GIDI Round 5 Important Information Update

Abatement Cost for EECA EB1&2 – Error in calculations

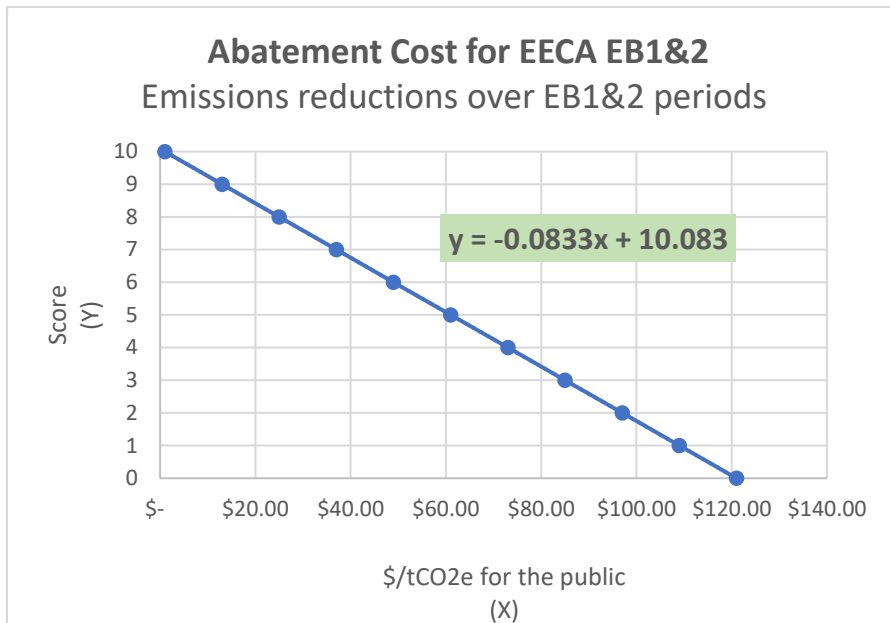
Unfortunately, the Abatement Cost for EECA EB1&2 graph on page 23 of the Request for Proposals (RFP) has a minor error. The existing graph in the RFP Section 5.8.5 calculates the cost up to \$110 \$/tCO₂e, but the range should be up to \$121 \$/tCO₂e to reflect the scoring table. Please use this updated graph (and formula) below for your calculations in the Financial Assessment Template. If you have already submitted your Proposal, EECA will adjust the numbers when the Proposal is evaluated by the Technical Advisory Group.

Abatement Cost for EECA EB1&2	
Score	\$/tCO ₂ e (≥)
0	121
1	109
2	97
3	85
4	73
5	61
6	49
7	37
8	25
9	13
10	1
